VALIDATION/VERIFICATION REPORT

ACR VALIDATION/VERIFICATION OF THE NORTH FLORIDA LAND TRUST
FOREST CONSERVATION (ACR722)

REPORTING PERIOD 1

Date: 11/4/2024
Version 2.1

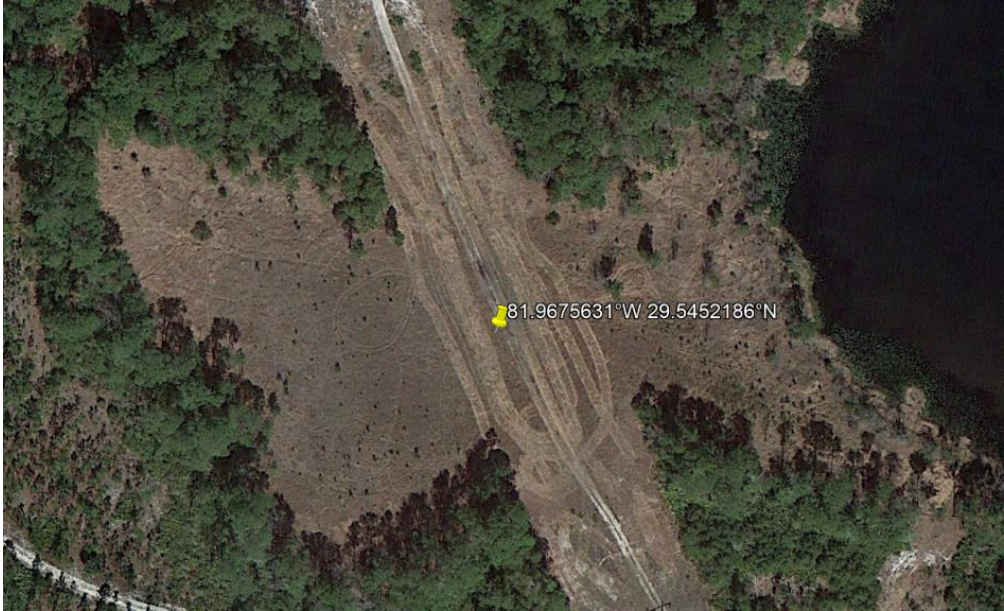
Verifier Issue	Issue ID:	23-8	Status: Closed	Checked by: MD	Date Identified	11-May-23
ACR Standard ref	GHG Plan Section	Significance	Issue Description		Comments	
ACR Standard v7.0, 2.B.1; ACR IFM Methodology v1.3, B2		Clarification. <i>May impact conformance; no materiality</i>	<p>When reviewing the property deeds, verifiers could not find deeds & parcel descriptions for the following Parcels:</p> <p>(1) The provided deed (Carter Recorded Deed.pdf) (part of the Trail Ridge Preserve) covers the Carter, George et al parcel and not the James Carter parcel. The Carter, George et al. parcel is not included in the project, however, the James Carter parcel is.</p> <p>(2) The deeds provided for the Little Rain Lake Preserve do not cover project lands in T8S, R24E, section 8. Please provide these deeds or if they were provided, please reference where we can locate them.</p> <p>(3) When reviewing the deed description for the Putnam Lake Preserve, in T11S R23E, Sections 13 & 14, the south boundary of the project area is described as Little Orange Creek. The NHD water flowlines do not line up with the PP GIS property boundary on the stream. What is the basis for the PP stream boundary in this location? Is correction warranted?</p>		<p><i>NFLT_Stratum_20210203.shp</i> <i>Putnam Lake Preserve > Deed.pdf</i> <i>NHDPLUS_H_0308_HU4_GDB</i></p>

<p>(1) After review of the provided <i>Carter Recorded Deed</i> again, the VB sees it is the same as the originally provided deed and it does correctly describe the James Carter parcel. Sorry for the mistake. This issue item is closed.</p> <p>(2) Regarding the Little Rain Lake Preserve project land in T8S, R24E, Section 8. The PP has provided duplicates of deeds of those originally submitted. None of these deeds appear to cover the land in Section 8. Please provide the necessary deed or point out where these lands are described in the provided deeds. This issue item remains open until supporting ownership information has been provided for this area.</p> <p>(3) In T11S R23E, Sections 13 & 14, the south boundary of the project area is described as Little Orange Creek. The NHD water flowlines do not line up with the PP's spatial data project boundaries. However the PP replies that the tax parcel stream line was used as the basis of the stream boundary. Verifiers reviewed the county tax parcel viewer for this area and confirmed the stream line used is the same as the tax parcel boundary. This issue item is now closed.</p>	<p>29413-A_29413-A <i>Deed_DEED_20191206.pdf</i></p> <p><i>Clay County 301 Land Deed.pdf</i> <i>Closing Deed.pdf</i></p> <p><i>Deeds.zip</i></p>

<p>January 22, 2024 Findings</p> <p>(2) Verifiers have reviewed the deed referenced by the PP via the provided link to the Country GIS Property portal. The deed reference is Book 4152, Page 2155 in the county registry of deeds and covers the project land in T8S, R24E, Section 8. This closes this issue item and the entire 23-8 issue is now closed.</p>	<p>https://qpublic.schneidercorp.com/Application.aspx?AppID=830&LayerID=15008&PageTypeID=4&PageID=6756&KeyValue=08-08-24-007016-000-00</p>
PP Response				
Date	PP Comment			Additional evidence submitted for review by PP
12-May-23	Please see deeds.zip. Also note the Putnam Lake Preserve boundaries have been modified such that the property aligns with county tax appraisal records.			<p><i>Deeds.zip</i></p> <p><i>NFLT_Stratum_20230630.shp</i></p>
28-July-23	23-8-2: Please see the link which takes you directly to the online Country GIS Property portal, where all deeds are available for this tract.			<p>https://qpublic.schneidercorp.com/Application.aspx?AppID=830&LayerID=15008&PageTypeID=4&PageID=6756&KeyValue=08-08-24-007016-000-00</p>

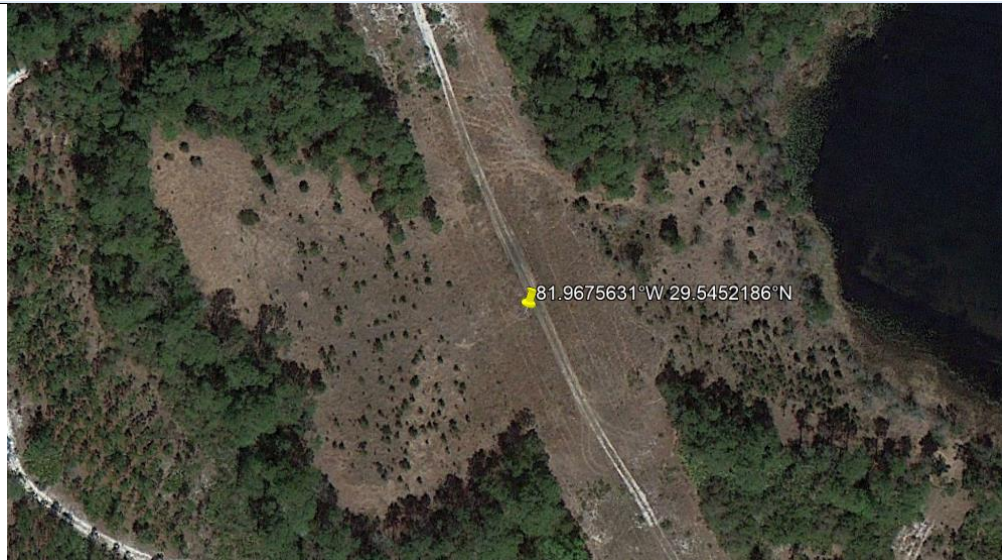
Verifier Issue	Issue ID:	23-9	Status:	Closed	Checked by:	MD	Date Identified	11-May-23
ACR Standard ref	GHG Plan Section	Significance	Issue Description				Comments	
ACR Standard v7.0, 2.B.1;		Clarification.	In reviewing the submitted spatial data, verifiers noticed numerous instances where the project boundaries (provided Stratum shp) do not align with the properties boundaries				<p><i>NFLT_Stratum_20210203.shp</i></p> <p><i>NFLT_CarbonProject_Properties.shp</i></p>

ACR IFM Methodology v1.3, B2, D2		May impact conformance; no materiality	(CarbonProject_Properties.shp). In some cases whole parcels are offset whereas other instances they line up perfectly. Although the differences are not great, they can cause confusion and erroneous verification assessment results (e.g., reviewing plot allocations or assessing walk-thru plots during a site visit). Verifiers have provided spatial data showing points of several examples of these observed discrepancies (Check points.shp - see points 6, 22 and 23). Also, please clarify what aerial imagery was used for project area delineation and projection used in GIS.	<u>Verifiers submittal:</u> VB_CheckPoints_NFLT_5-12-2023.shp
			July 12, 2023 Findings Verifiers understand the <i>NFLT_CarbonProject_Properties.shp</i> should be disregarded and the revised <i>NFLT_Stratum</i> spatial data should be used for the boundaries of the project area. Regarding the check points (6, 22 and 23) the VB agrees with the PP's responses. On check point 6 the PP adjusted the line to match the tax parcel line, a slightly more conservative change. On check point 22, the PP adjusted the boundaries to match the tax parcel lines, this better aligns with aerial imagery features such as vegetation changes as well. On check point 23, the tax parcel line appears to not align accurately with features on the aerial photos and there is no overlap so the PP chose to be conservative and not change the boundary. Verifiers are satisfied with these project boundary spatial data revisions and as such this issue is now closed.	<i>NFLT_Stratum_20230630.shp</i> ; <i>VVB_checkpoints_PPResponse_2023 0630.shp</i>

PP Response				
Date	PP Comment			Additional evidence submitted for review by PP
12-May-23	23-9: Please disregard <i>NFLT_CarbonProject_Properties.shp</i> . Please use the updated strata shapefile for official project area delineation. Please also see our individual responses added to the attribute table for the VVB check points. The aerial imagery was the Imagery ESRI basemap using on-the-fly projection.			<i>NFLT_Stratum_20230630.shp</i> ; <i>VVB_checkpoints_PPResponse_20230630.shp</i>

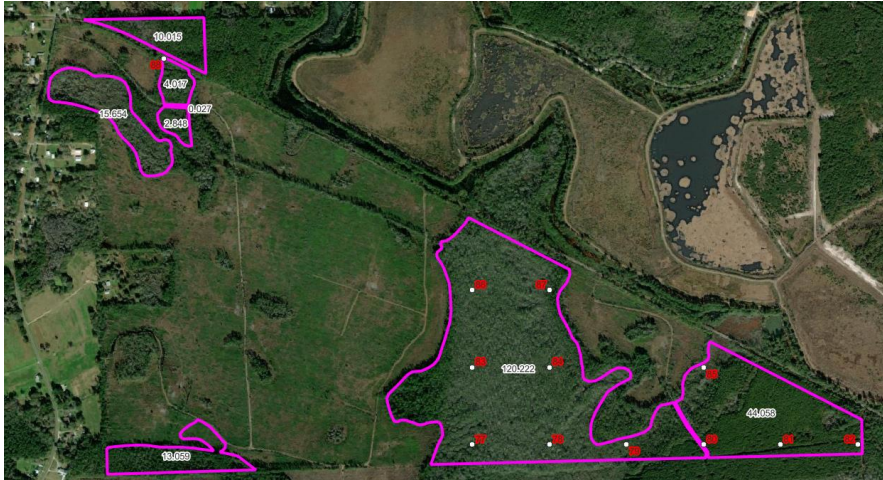
10 Additional) As described above the updated approach to determining SMZ buffers has resulted in the Plots 98, 100, 101 and 106 now being allocated to SMZs and thus the Let Grow scenario as the Project does not employ any harvesting in SMZ areas. Please see the table below for a description of the original baseline prescription (as shown in the previously submitted Baseline File Set) and the current prescription applied:

Plot	Original Baseline Rx	New Baseline Rx
98	Clearcut in Year 0 and Year 60	Let Grow
100	Clearcut in Year 10 and Year 70	Let Grow
101	Clearcut in Year 0 and Year 60	Let Grow
106	Clearcut in Year 0 and Year 60	Let Grow

Additionally, the ERT calculations, GHG Plan, and MR have all been updated to reflect these changes.
